UNITED STATES PATENT AND TRADEMARK OFFICE

10/564,003

Office Action Summary	Application No. 10/564,003	Applicant(s) ULLRICH ET AL.	
	Examiner RYAN DODD	Art Unit 4134

DETAILED ACTION

US 2003/0038538 A1

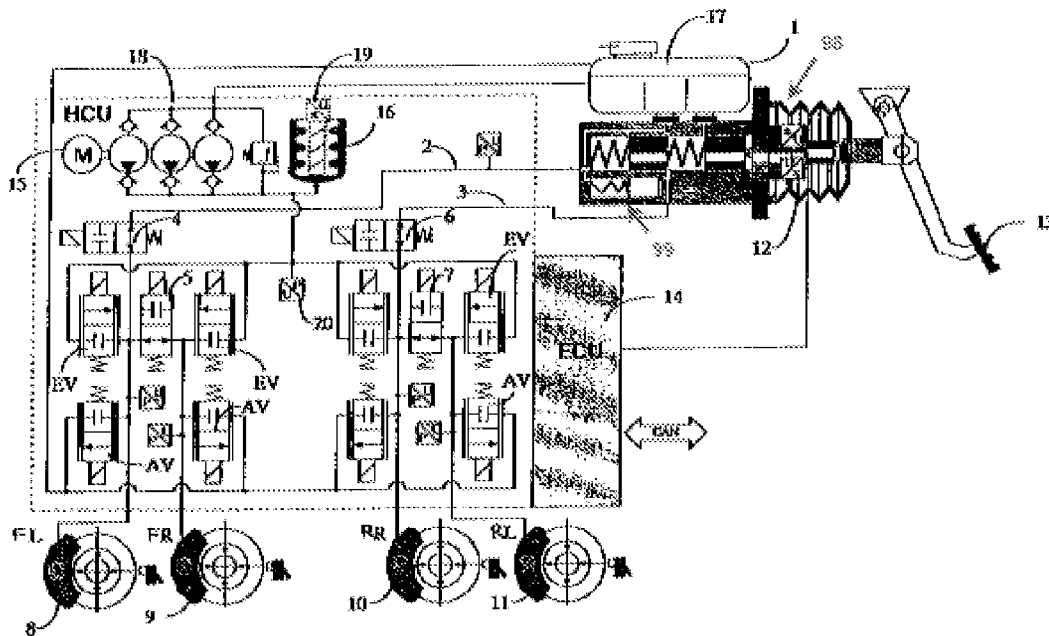
11. As to claim 9, Niepelt '538 discloses a method of monitoring an electrohydraulic brake system for motor vehicle, having a master brake cylinder (master cylinder 1) operable by a brake pedal (13), a travel simulator (99) cooperating with the brake pedal (13), at least one pressure source actuatable by an electronic regulation and control unit

(ECU 14) which is formed of a high-pressure accumulator (pressure fluid accumulator 16) that can be charged by means of a pump (three-piston pump 18), and the pressure of the pump can be applied to wheel brakes (8,9) of the vehicle which are connectable to the master brake cylinder (1), on the other hand, by means of at least one hydraulic connection (hydraulic conduit 3) that can be closed by means of a separating valve (6), with a device (33) for detecting the driver's deceleration request (98), and with each one inlet valve (EV) connected upstream of the wheel brakes (8, 9) and an outlet valve (AV), the method comprising:

closing a separating valve (4) associated with a vehicle axle (page 2, paragraph 18, last two lines),

opening inlet valves associated with the vehicle axle for the purpose of displacing pressure fluid volume into wheel brakes of the vehicle axle, while determining values representative of a hydraulic pressure introduced into the wheel brakes and a displacement of pressure fluid volume (page 2, paragraphs 19 and 20, in this case the values representative of a hydraulic pressure introduced into the wheel brakes are determined at a preset level of roughly 1 or 5 bar, and the displacement of fluid volume (filling quantity, volume of pressure fluid conducted) is determined by a sensor 19); and

evaluating the values to judge the condition of the wheel brakes (emergency braking capability, page 2, paragraph 20, last two lines).

12. Niepelt '538 does not explicitly disclose "deactivating an electronic control associated with a charging operation of a high-pressure accumulator and carried out by an electronic regulation and control unit." Admittedly, Niepelt '538 teaches a charging of the accumulator 16 as an initial step in its method (page 2, paragraph 18, lines 5-6).

14. As determined from the prior art it is customary to deactivate an electronic control associated with a charging operation of a high-pressure accumulator (in order to stop a pump) once the pressure of the accumulator reaches a desired level. So, it is safe to deduce that deactivating an electronic control associated with a charging operation of a high-pressure accumulator was inherent to Niepelt's step of charging the accumulator (page 1, paragraph 7). Thus, Niepelt '538's method reads on this claim as written.
